ADDENDUM NUMBER 2

- 1.01 DATE: JUNE 10, 2021**
- 1.02 PROJECT: THOMAS WING AT CARVER COMPLEX HVAC RENOVATION**
- 1.03 PROJECT NUMBER: DCM NO. 2021321**
- 1.04 OWNER: ALABAMA A&M UNIVERSITY**
- 1.05 ARCHITECT: NOLA | VAN PEURSEM ARCHITECTS, PC**

Roof Demolition
MECHANICAL FLOOR PLAN
 1/8" = 1'-0"

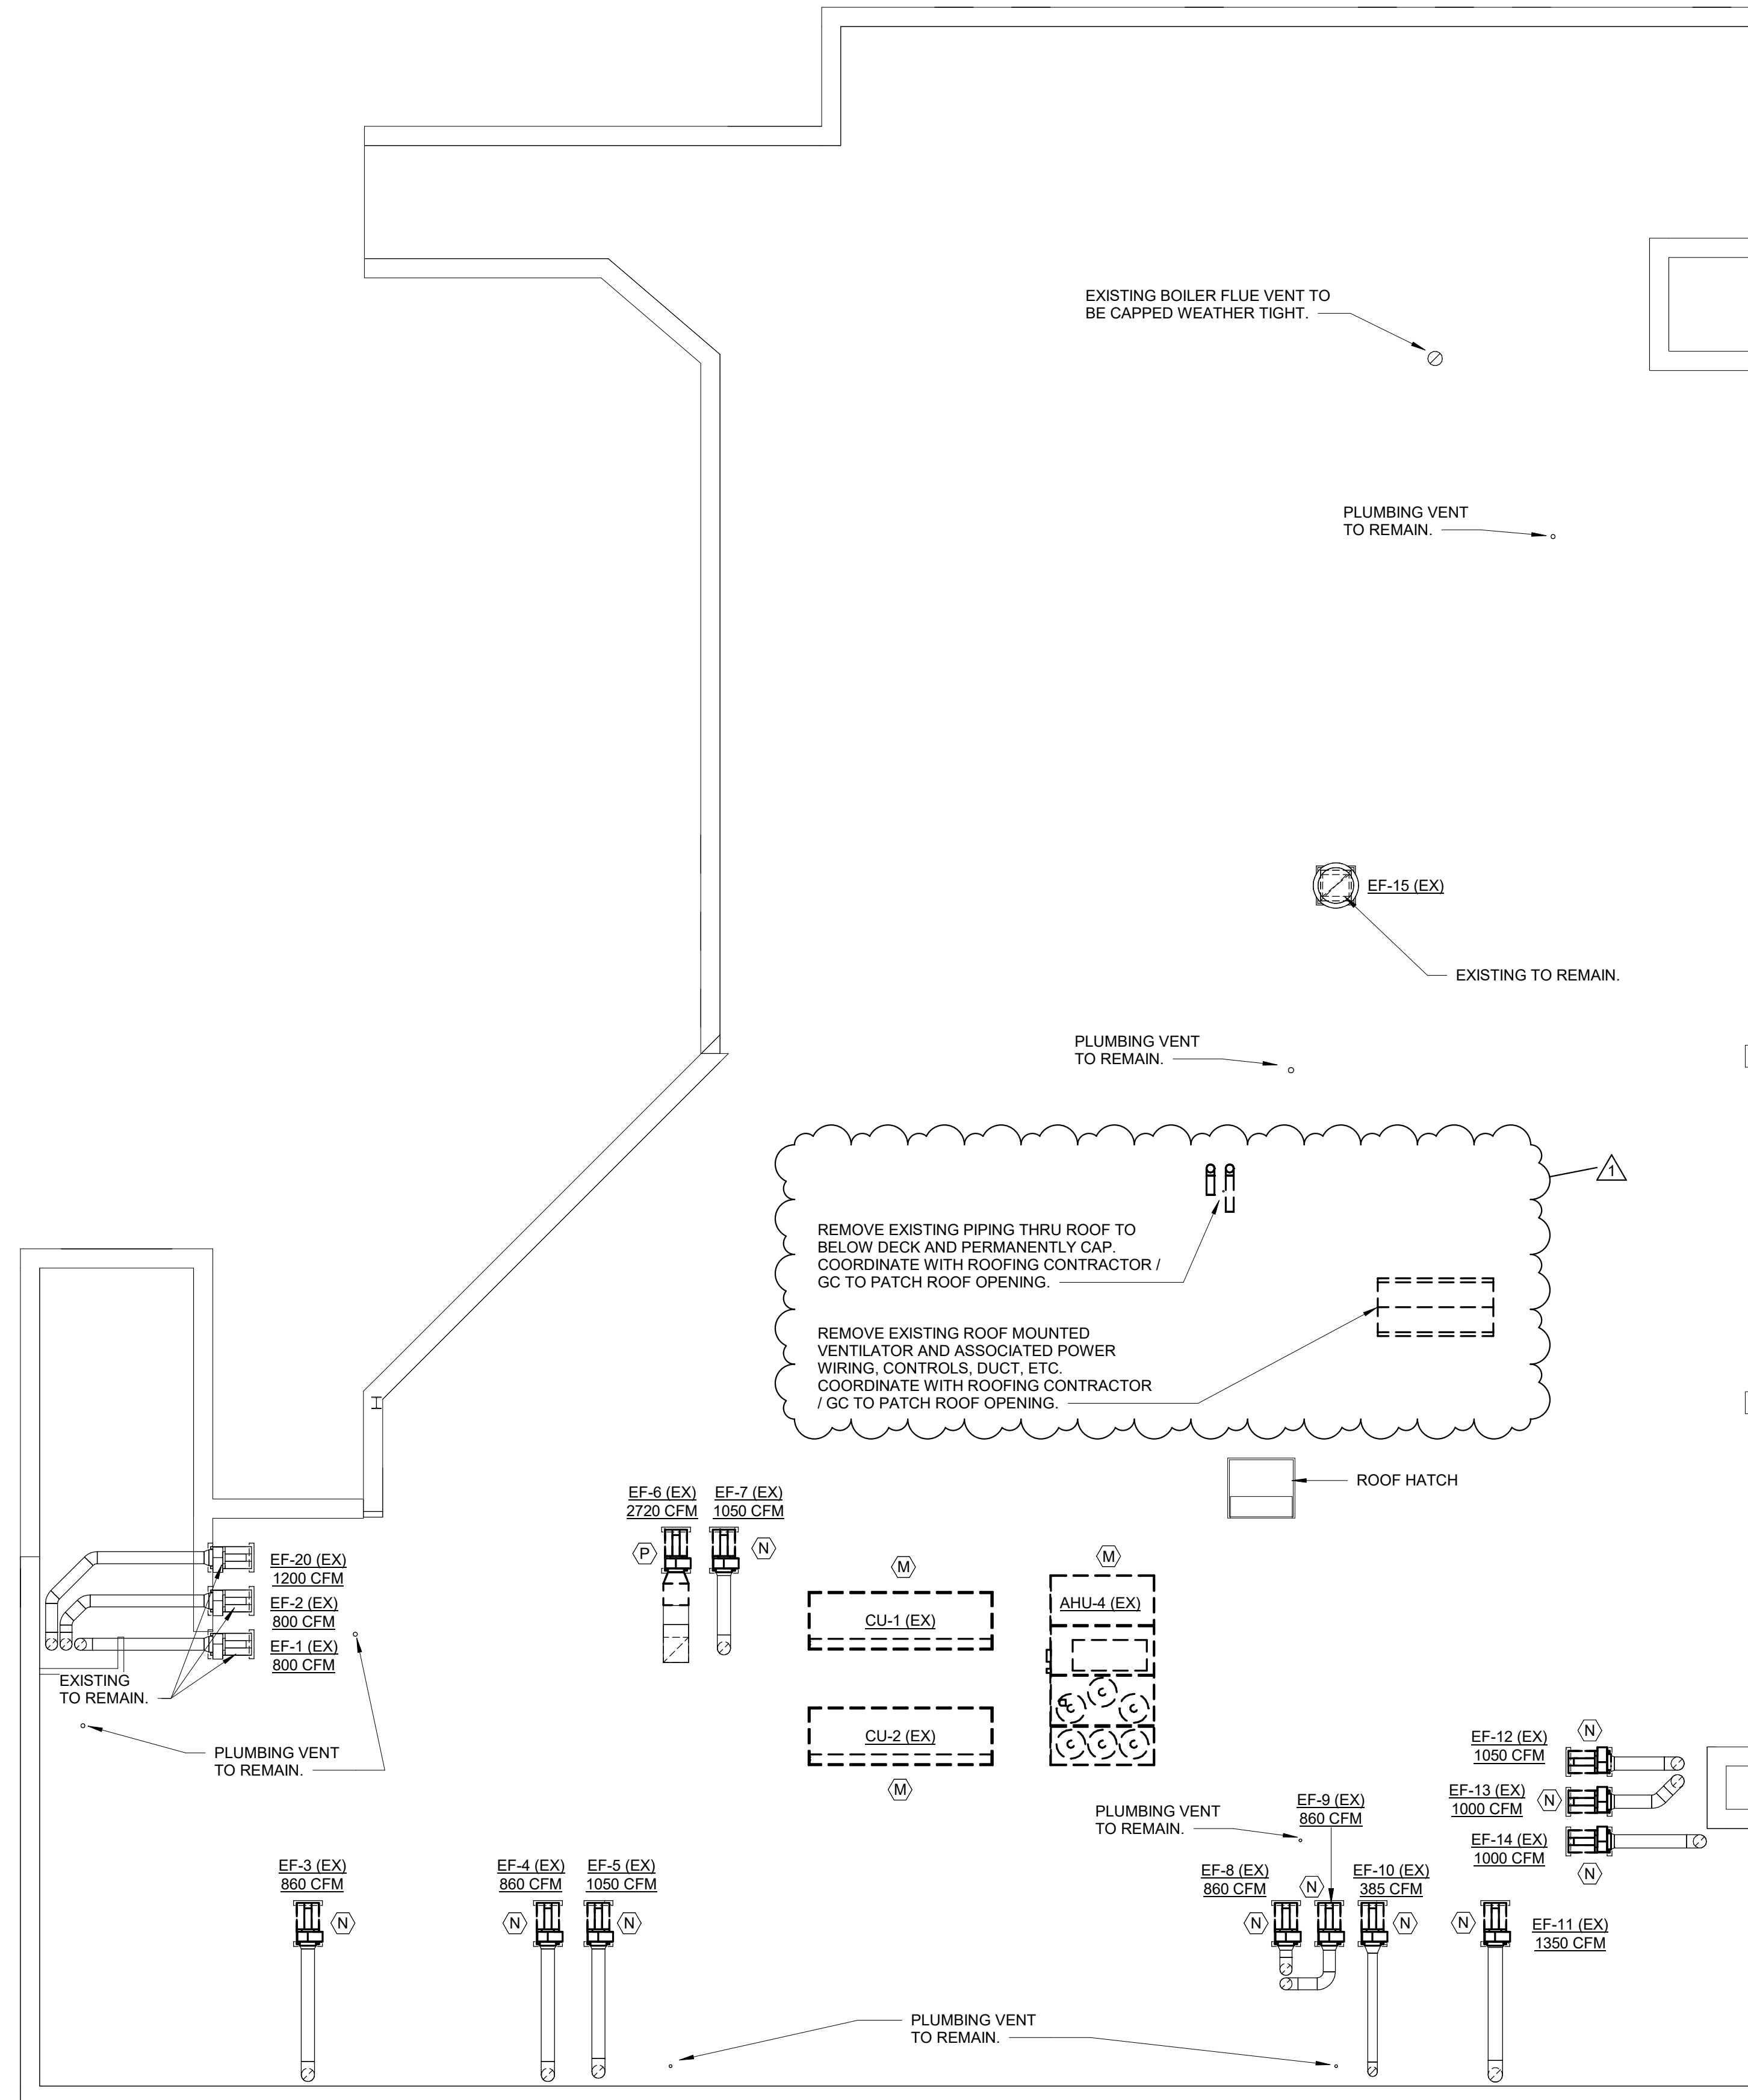
4.03 SHEET M-1.4 - MECHANICAL FLOOR PLAN – ROOF DEMOLITION:

A. Replace this sheet in its entirety. Changes include:

1. Added existing roof mounted ventilator to the roof demolition plan. Existing ventilator is to be removed and patch / modify the roof opening as required for the installation of the new roof mounted AHU.
2. Reworded note for the existing condenser water piping above the roof that fed the old cooling tower to be removed to below the roof. The roof openings are to be patched and sealed.
